RECEIPT DATE: 6-13-17 **ONSITE SEWAGE DISPOSAL SYSTEM**

**OSDS Plan  
5519 Green Bridge Road  
Dayton, MD 21036**

The OSDS Plan for 5519 Green Bridge Road has been reviewed with the following comments:

**SEPTIC PLAN TALL TREES**

APPROVAL DATE: 6-21-17 **PERMIT: CONSTRUCTION**

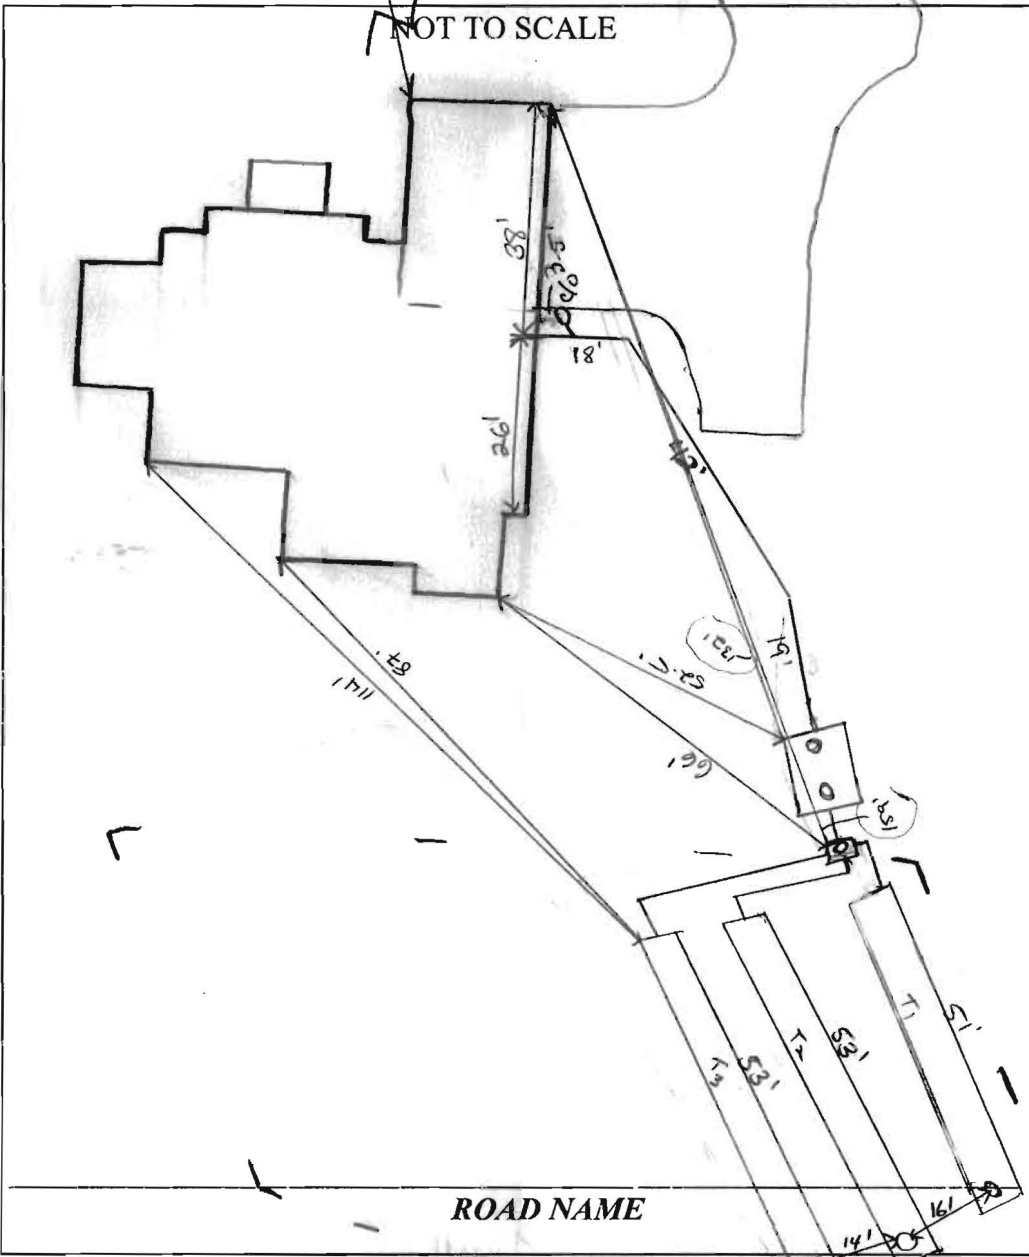
6/19/17 Tank location OK. SOA staked per plan. Install 3x5' trenches as indicated on plan. Call for inspection. Contractor has tank set up for Tuesday morning (6/20). (Kane)

6/20/17 Arrived on site after setting of tank. Saw construction of T<sub>1</sub>. T<sub>1</sub> is 51' due to constraint from poplar tree at distal end of trench. Contractor to start on T<sub>2</sub> before end of day. (K) 6/21/17 On site after completion of T<sub>2</sub> + T<sub>3</sub>. Checked baffles in tank + d box. Ran a speed level check in d box. Approved installation. (K)

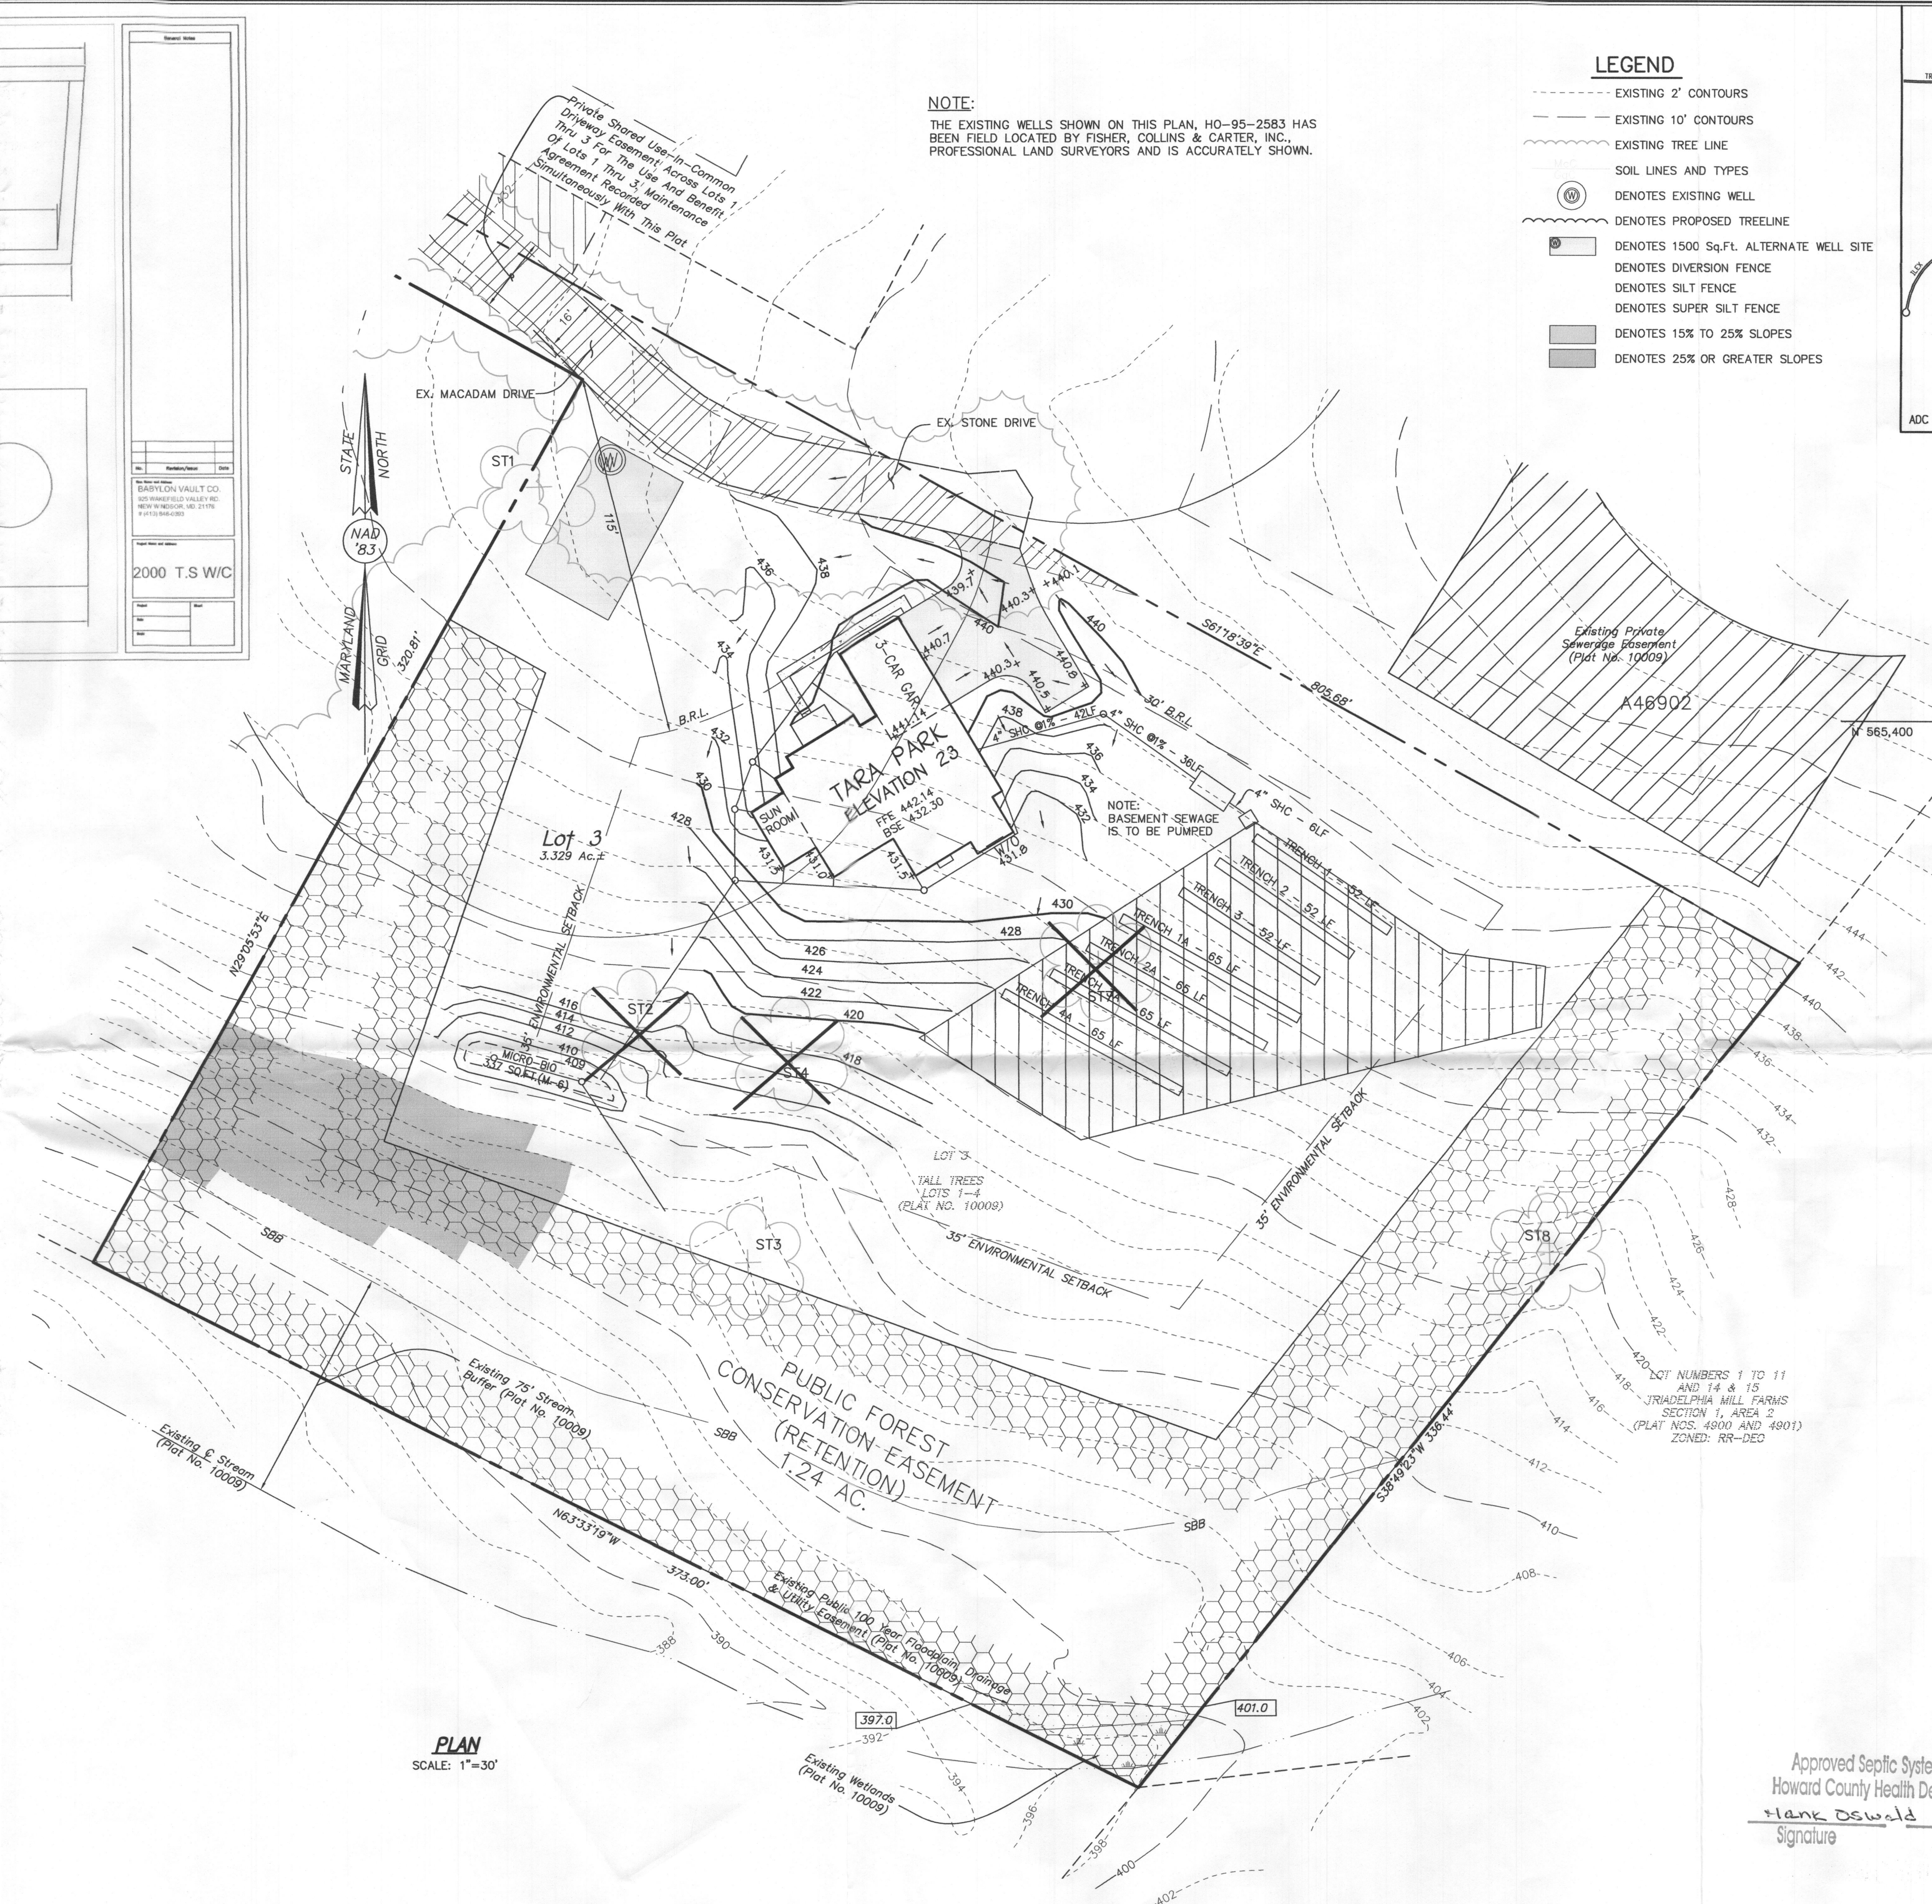
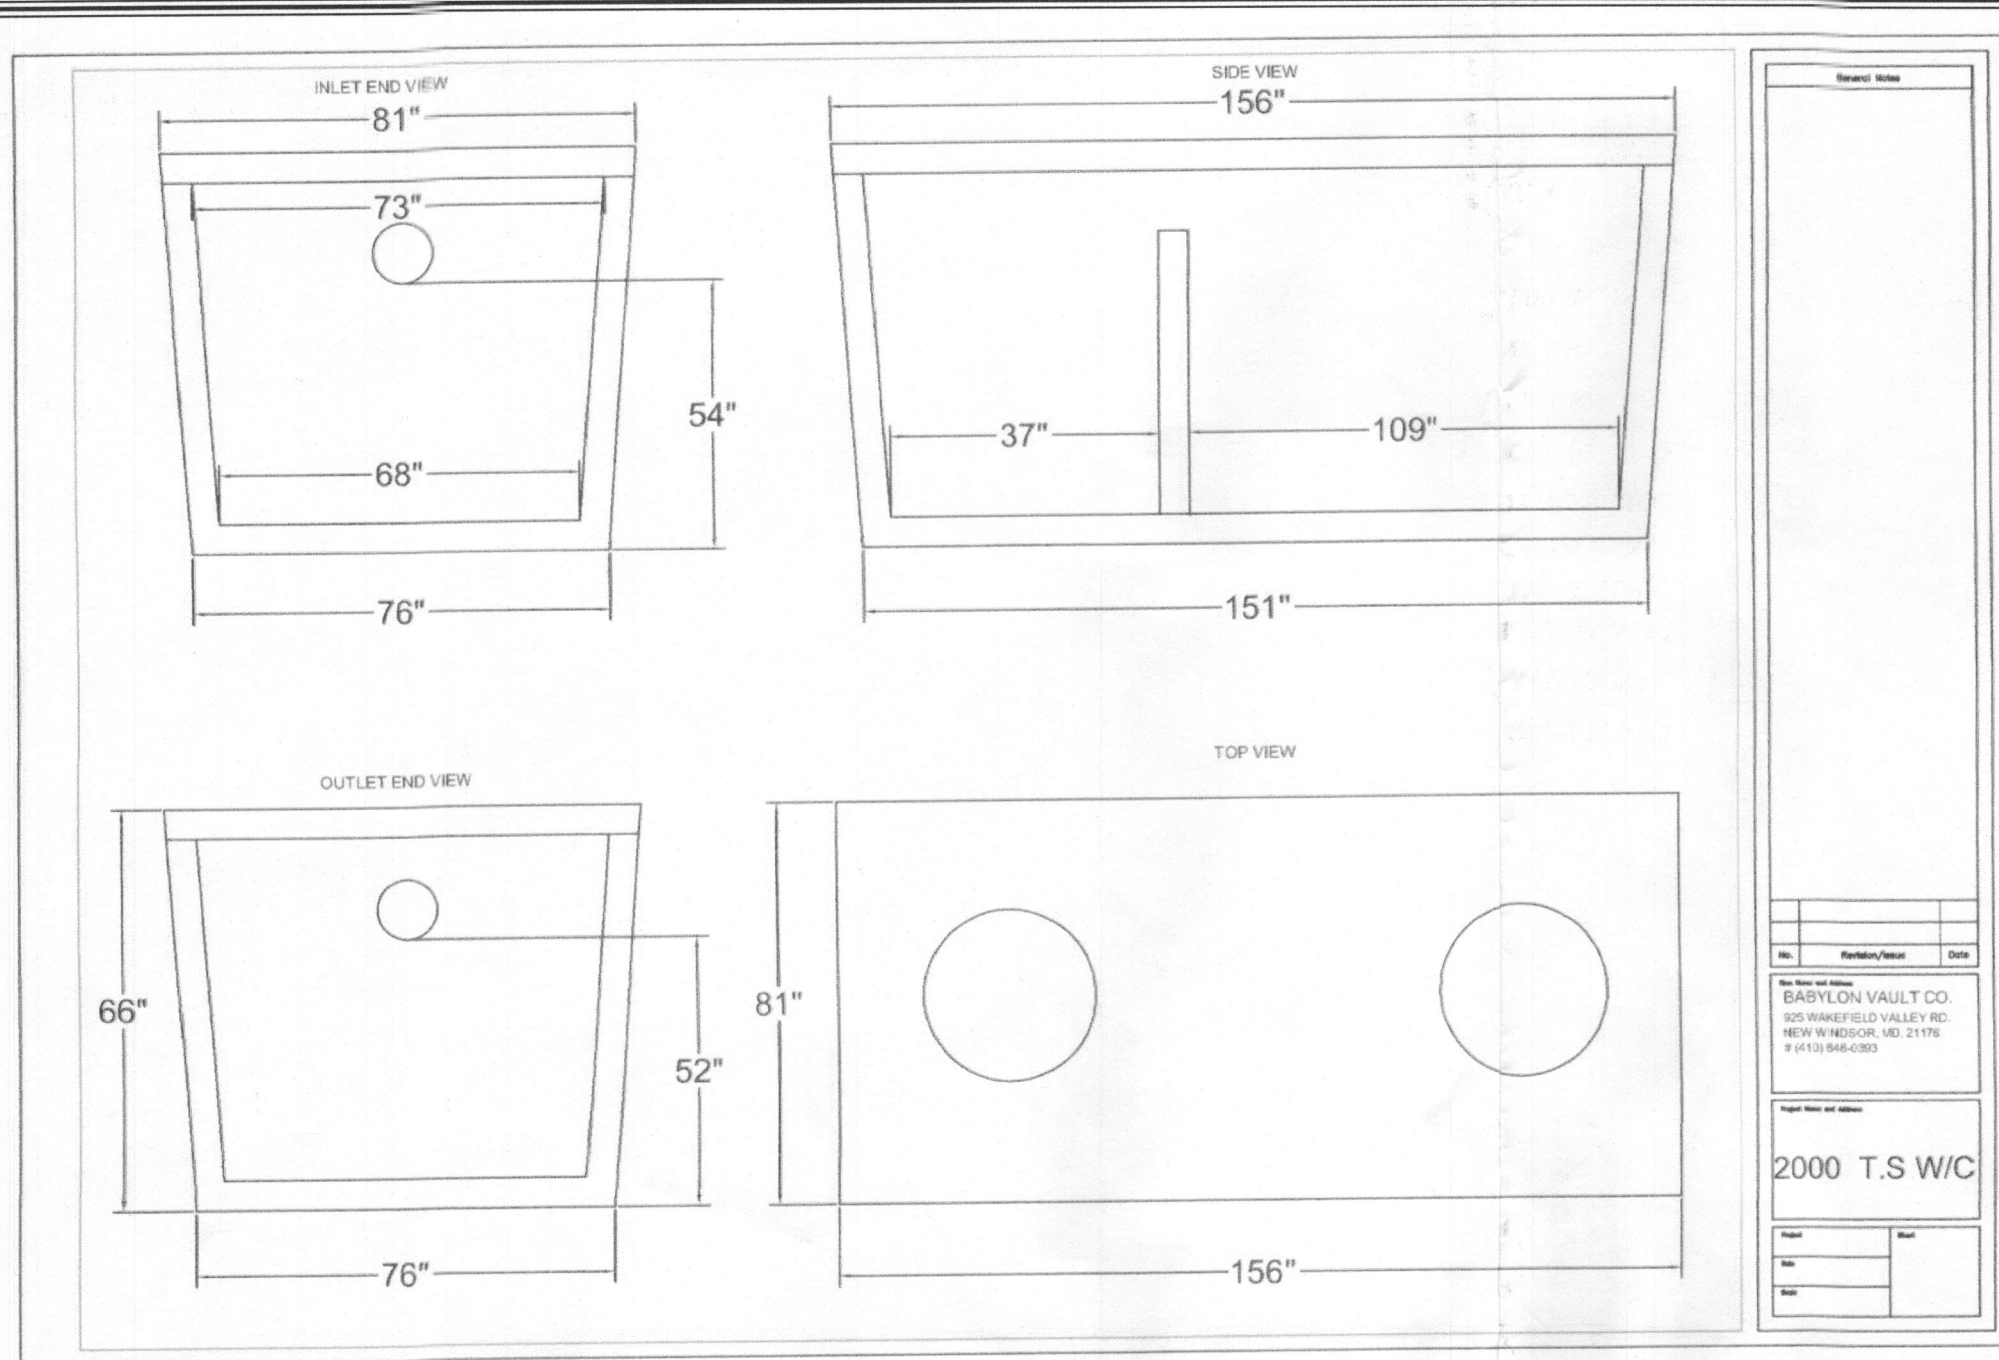
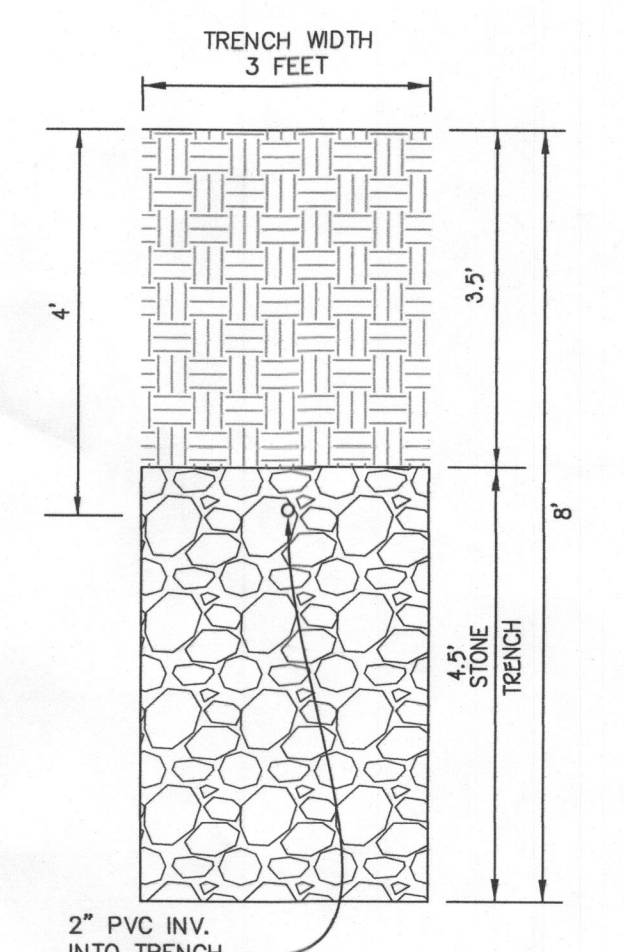
- 1.) Show how two systems fit within the sewage disposal area or all 3 systems if space looks limited.
- 2.) Show calculations for 1<sup>st</sup> replacement system.
- 3.) Minimum trench spacing is 10 feet for all trenches utilizing sidewall credit. Show correct trench spacing on layout.
- 4.) Delete the old 4"SHC wording on plan.
- 5.) Is this a 2000 gallon septic tank?

Enclosed please find Three (3) print copies of the revised Septic Plan addressing your comments dated April 27, 2017. This plan for 5519 Green Bridge Road is being submitted for your review and signature approval. Building Permit is under review as B16003986.
